Letter of Explanation for Variance

Property Address: 1208 Southbreeze Ln. Annapolis, MD. 21403

Permit Number: B02440932

CONFIRMATION OF PRE-FILE

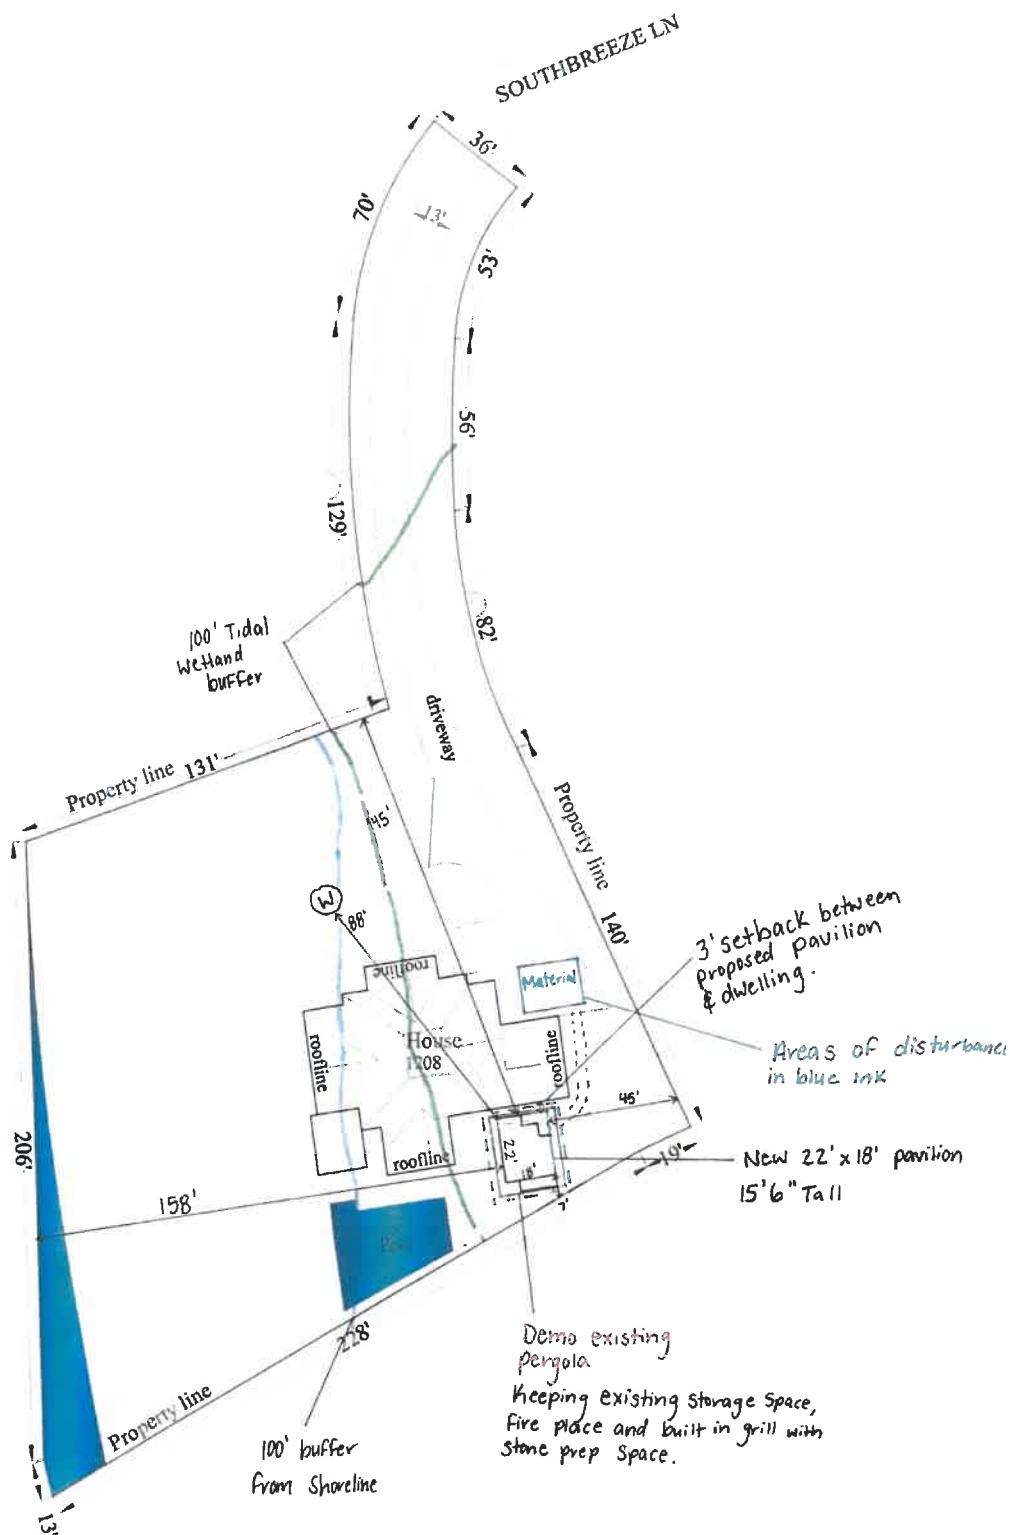
1. Revise the Site Plan to note the distance between the proposed pavilion and the dwelling.
2. Revise the Site Plan to note the height of the proposed pavilion.
3. The applicant is reminded, in order for the Administrative Hearing Officer to grant approval of the variances, the proposal must address and meet all of the applicable variance standards provided under Section 18-16-305. The Letter of Explanation should address each of those standards (a through c) and provide adequate justification for each of the variances required.
4. Although not required for the variance submission, site photos, elevations, and/or construction plans are very helpful in determining what is proposed, and strongly recommended to be included as support documents for the variance application.

1. No objection to the reconstruction of the existing pergola in the same foot print.
2. The proposed work will result in a decrease in coverage within the buffer.
3. The material stock pile area is over the existing driveway and the access to the construction area will constitute temporary disturbance.
4. Mitigation will be required with the permit application.
